24th August 2023

Our Ref: RMA/LC2402g_1 – EA Response Letter August

RE: PROPOSED REDEVELOPMENT OF LAND AT GROVE ROAD IN NORTHFLEET, KENT, DA11 9AX – ENVIRONMENT AGENCY RESPONSE LETTER (AUGUST 2023)

Our ref: KT/2022/129955/05-L01
Charged agreement ref:
ENVPAC/1/KSL/00566
Date: 29 June 2023

Figure 1: **More Vulnerable Land Uses on Ground Floor**

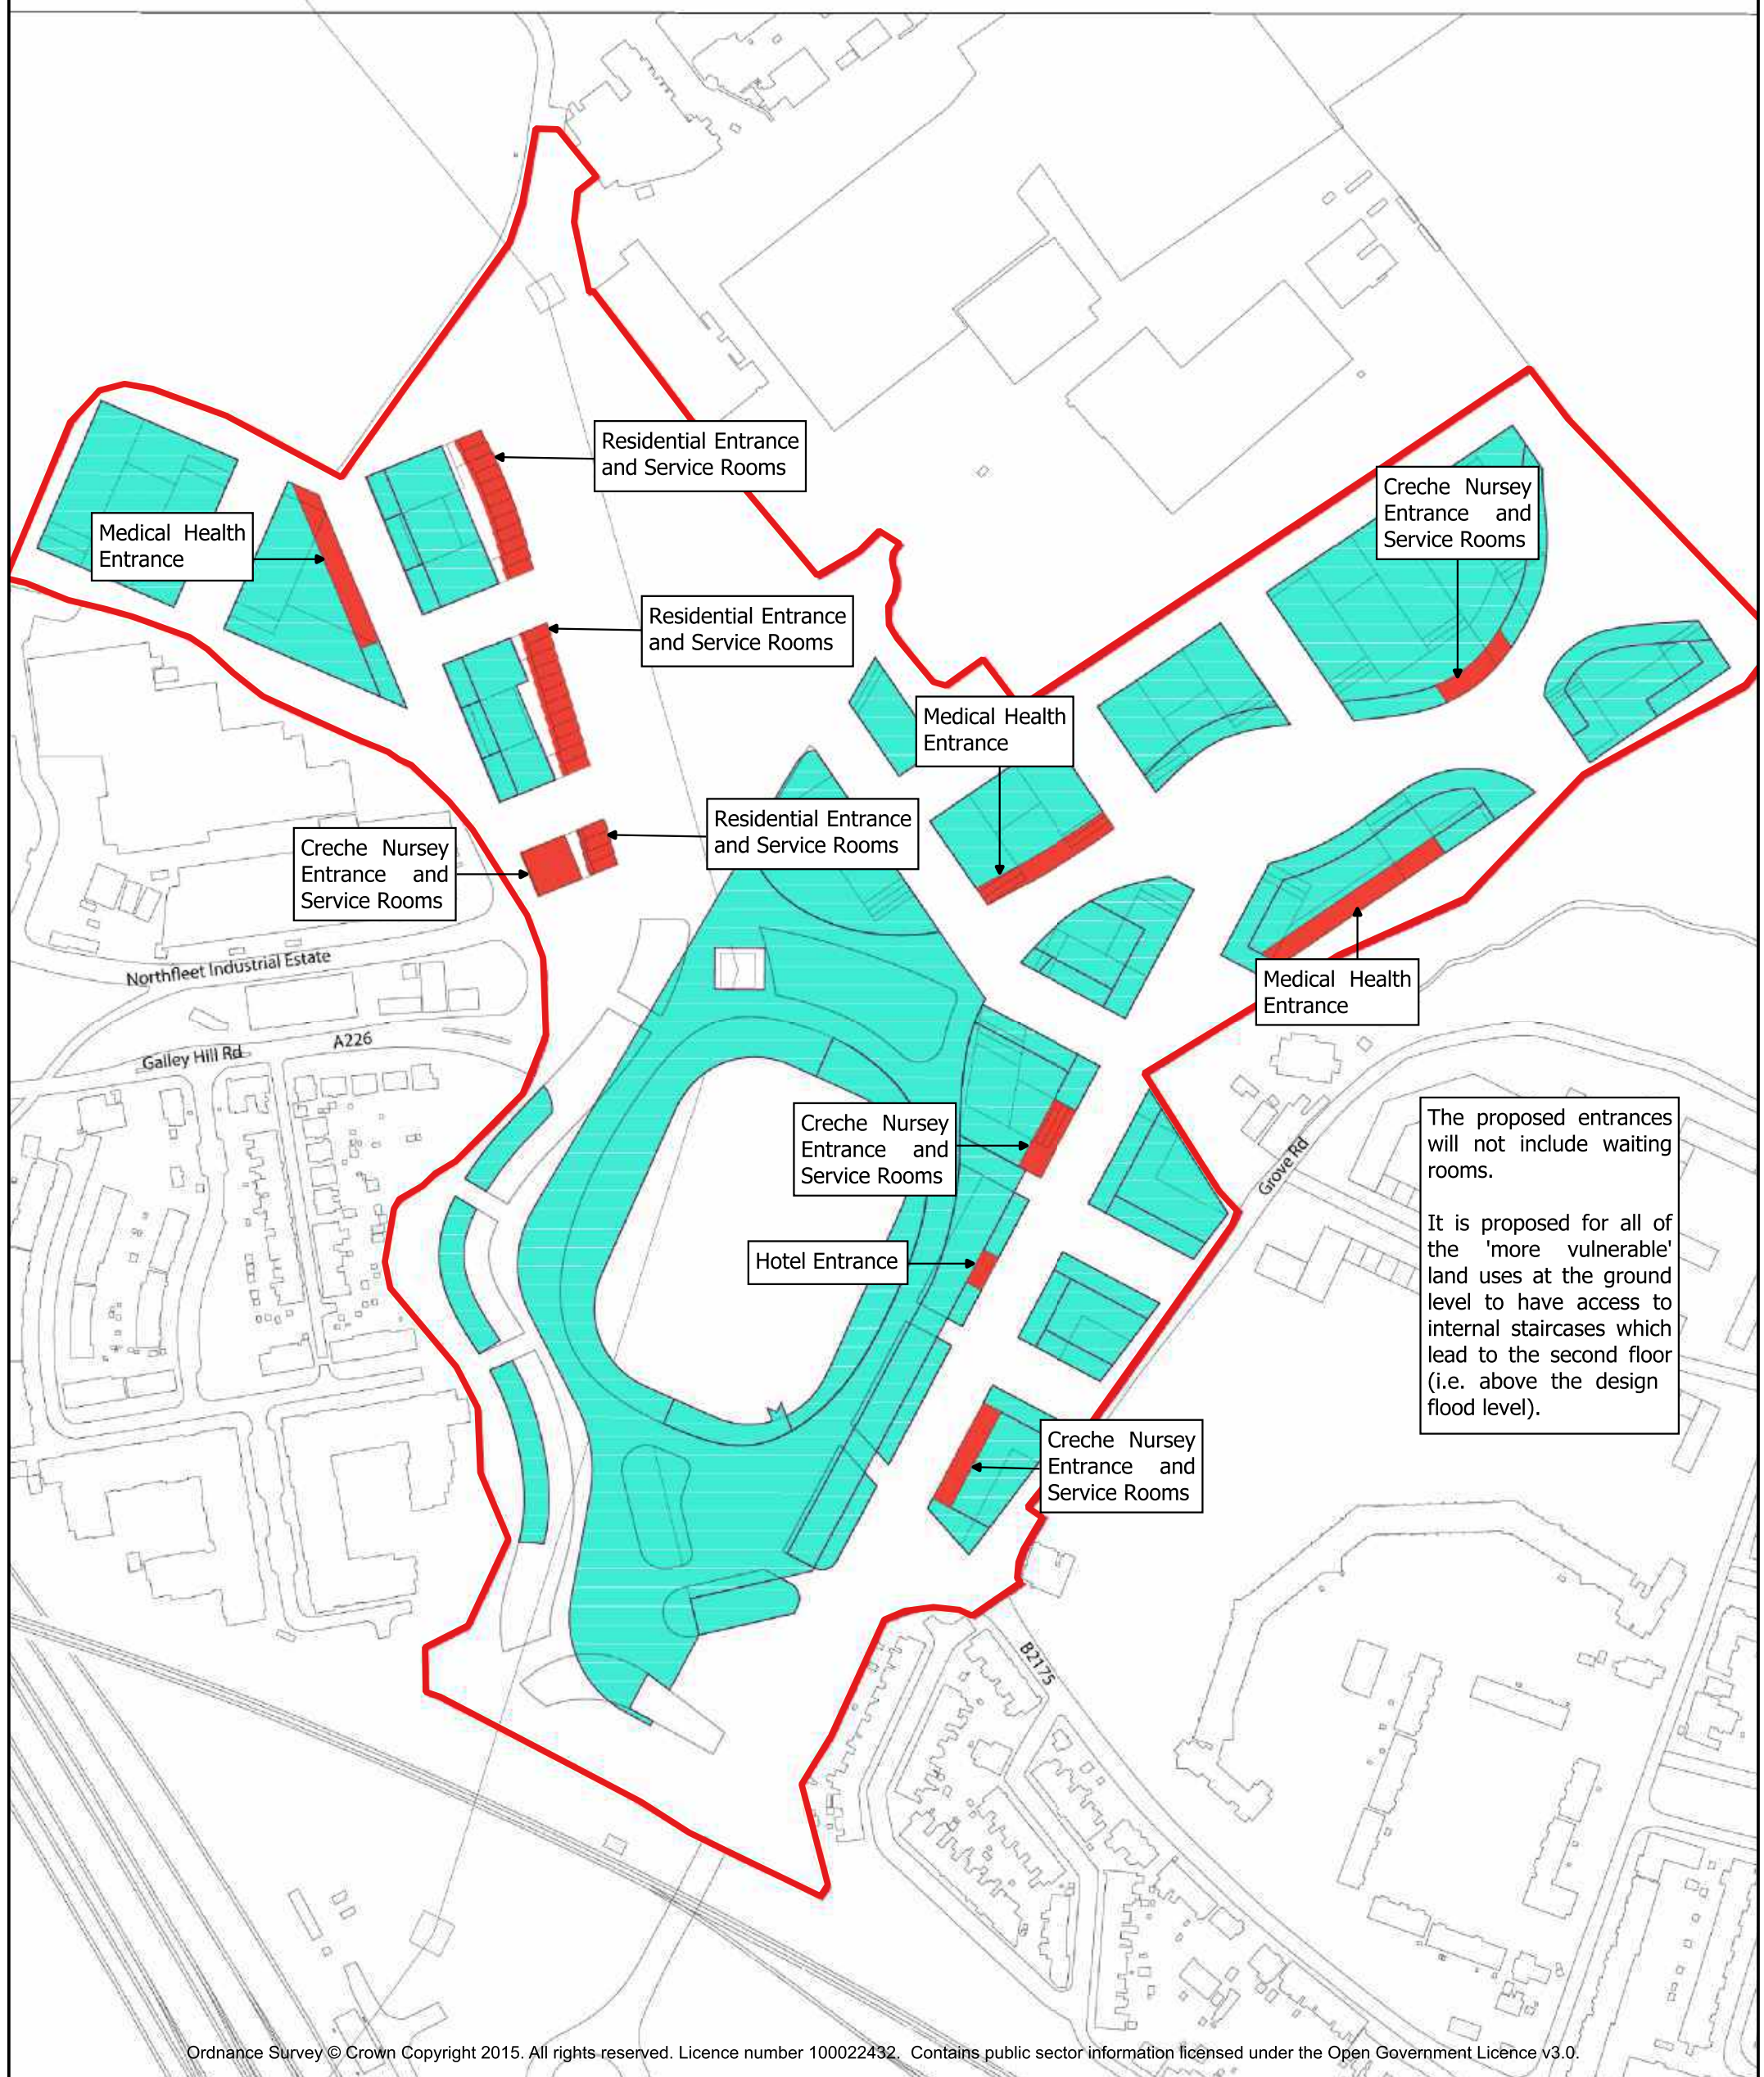
“Please send us drawings outlining what “more vulnerable” uses are below the flood level and we’d be happy to provide clarification on the above point”.

The majority of the ‘more vulnerable’ land uses will be located on the first floor or above to ensure that they are located above the design breach flood levels, this includes all sleeping accommodation. Although some of the ‘more vulnerable’ land uses are located below the design flood level, these will include ancillary uses such as entrances and service rooms for the ‘more vulnerable’ land uses located above (refer to Figure 1). The proposed entrances will not include waiting rooms and all of the ‘more vulnerable’ land uses at the ground floor will have access to internal staircases which lead to the second floor (i.e. above the design flood level).

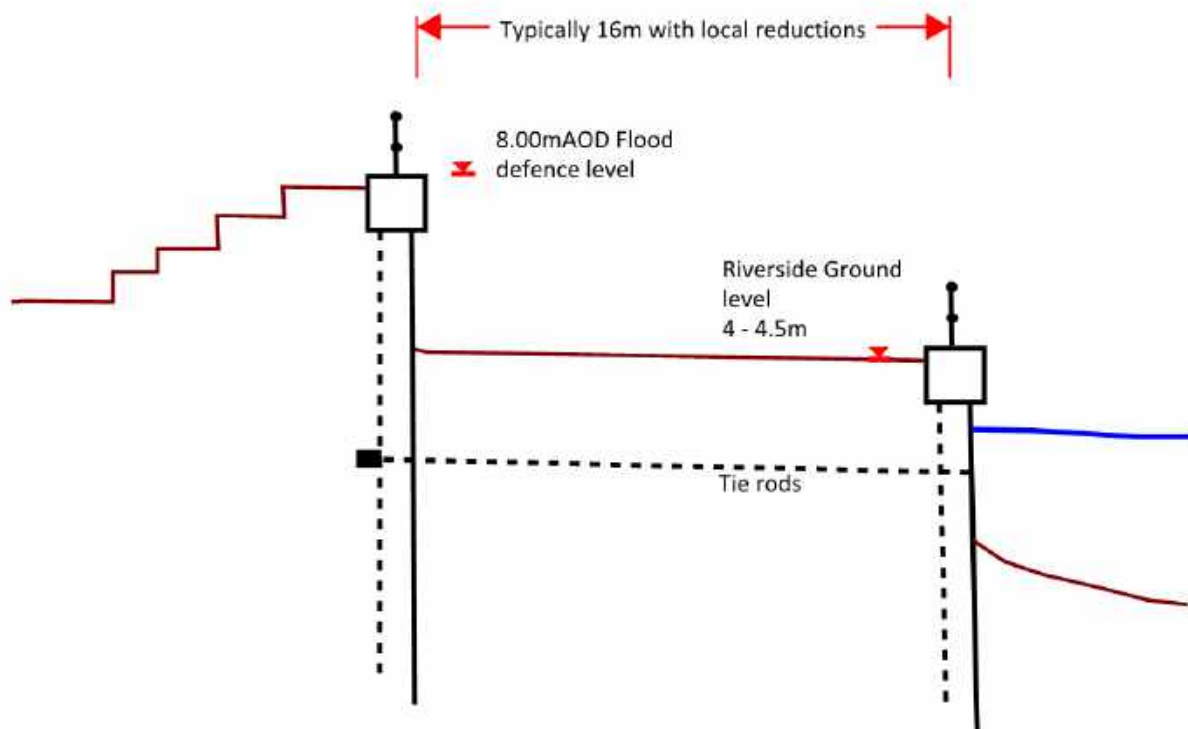
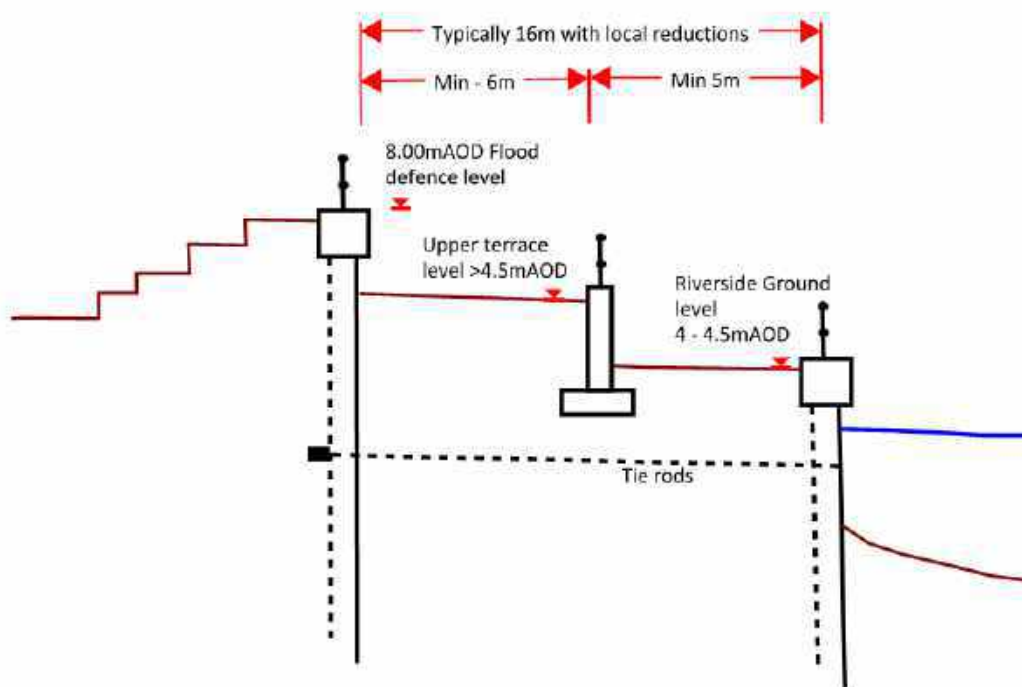
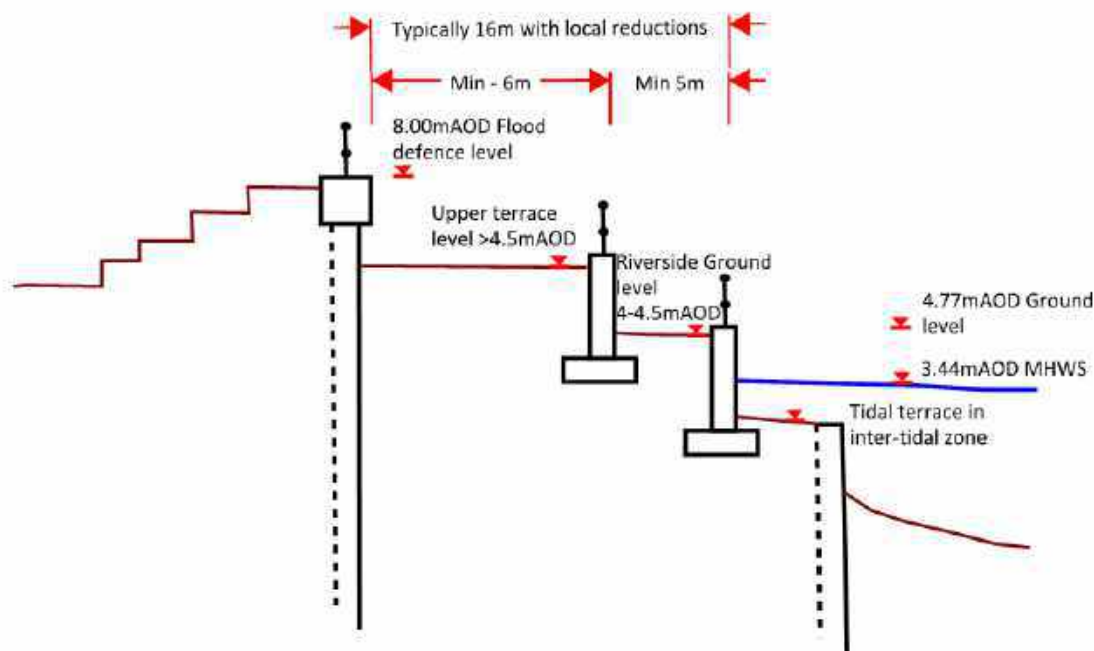
"Please note that the development must not prevent future maintenance and management of the flood defences, including any retreated defence".

With the submission of the River Wall Impact Assessment, it is considered that no further work is required at this outline planning stage and further detailed design of the river wall can be conditioned.
